Title: Advisory Committee on Reactor Safeguards
 Reliability and PRA Subcommittee Meeting
 Open Session

Date: Tuesday, May 2, 2017

The Subcommittee will hear the staff's presentation on the progress of the Level 3 PRA project, including the proposed format and contents of the planned project report.

NUREG-xxxx, “An Assessment of Site Risk for the Vogtle Electric Generating Plant, Units 1 and 2”

Bar Chart

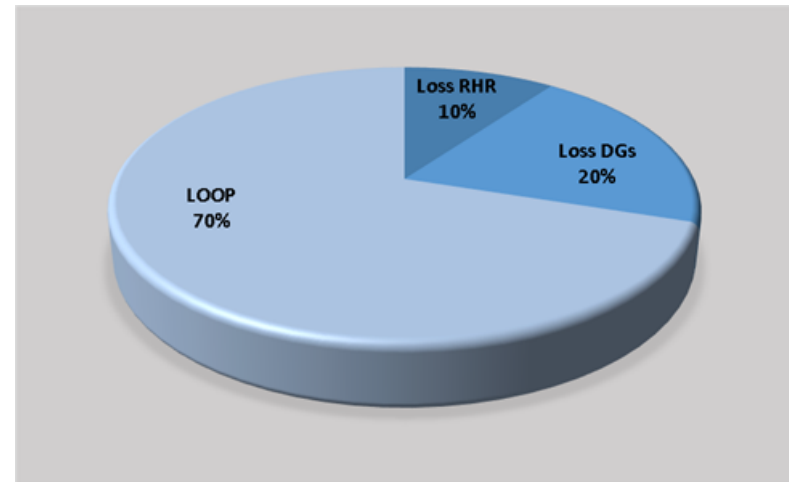
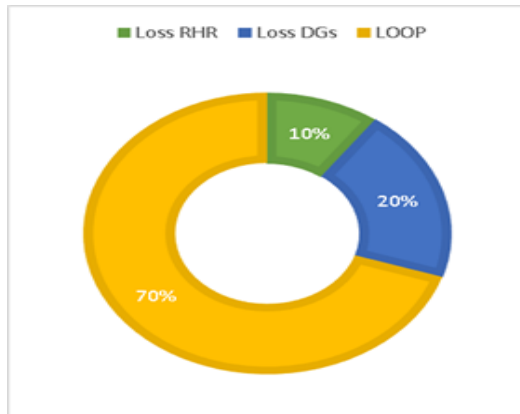
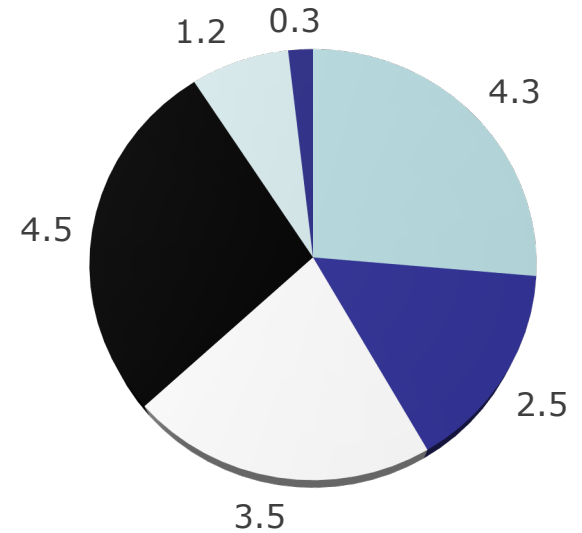
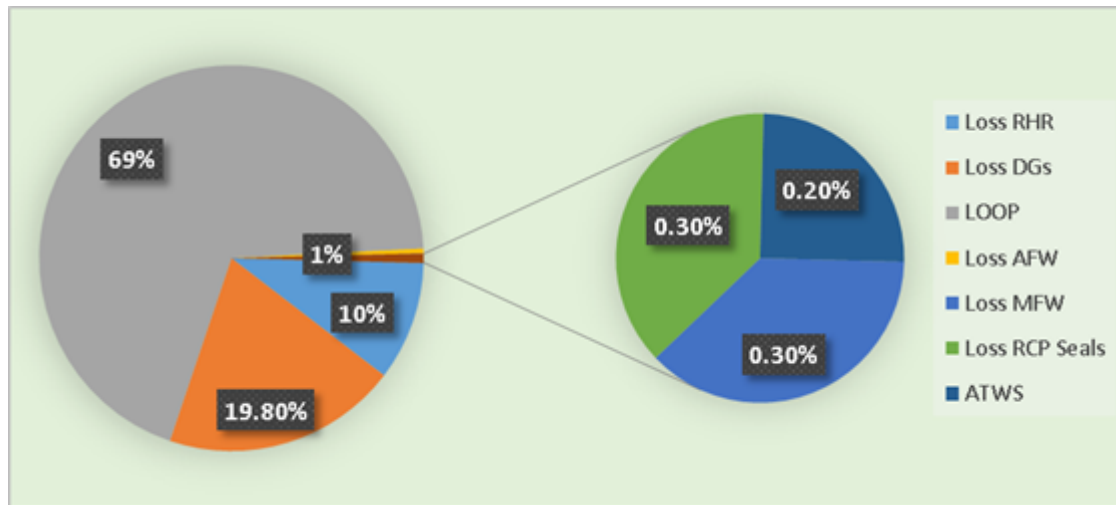
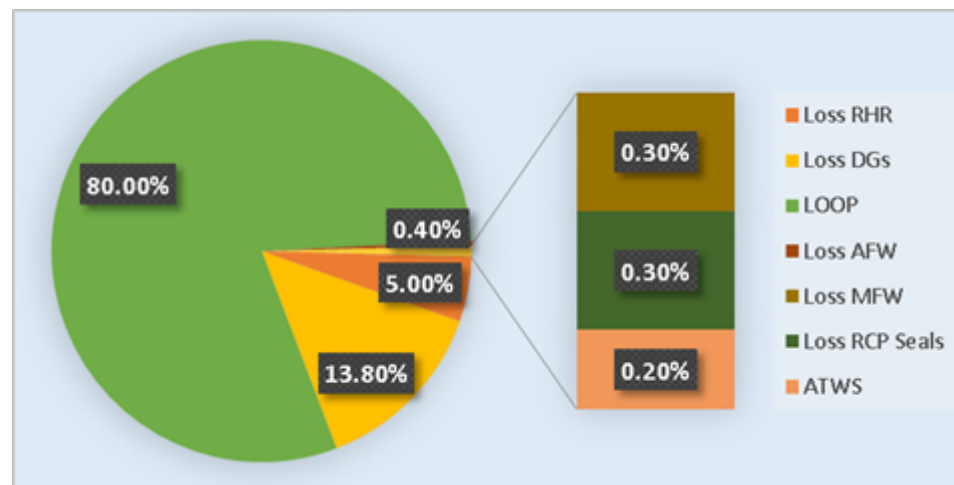
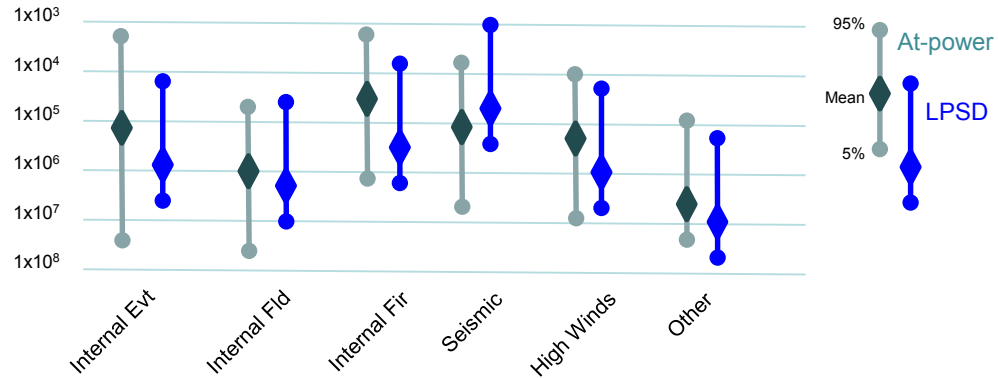
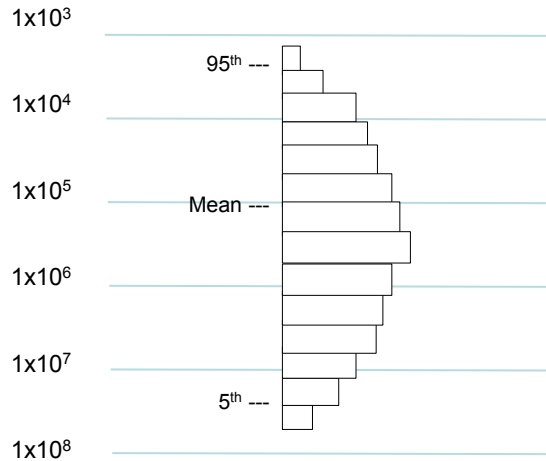
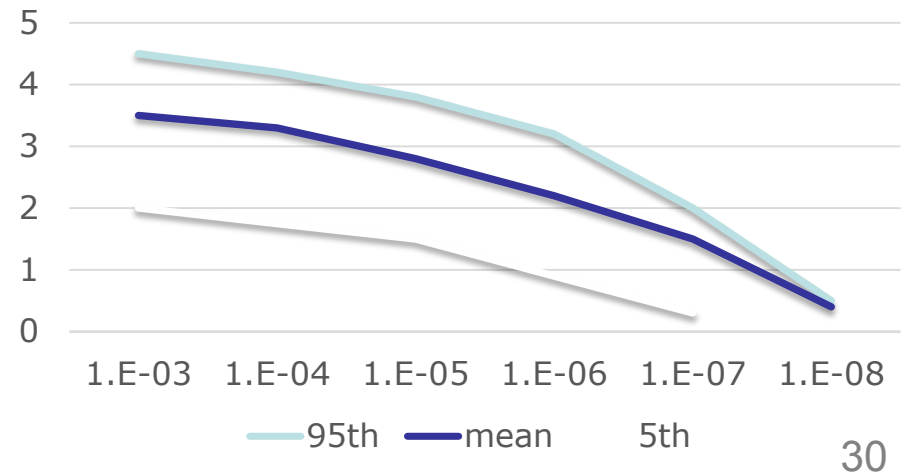
4 CHAIRMAN STETKAR: One other quick
5 comment on -- bar charts are -- I can read them,
6 but I often get fooled.

19 MEMBER BLEY: You might think --
20 something you haven't shown us, you might think --
21 and I've seen people do this, of having, whether
22 it's a bar chart or pie chart or whatever or curve,
23 both a logarithmic -- semi-log one and a linear one
24 so you really do pop these things at you that, you
25 know, we're seeing detail in this logarithmic kind

20 CHAIRMAN STETKAR: -- versus something
21 else that's very peaked and show, then, how the
22 means stack up.
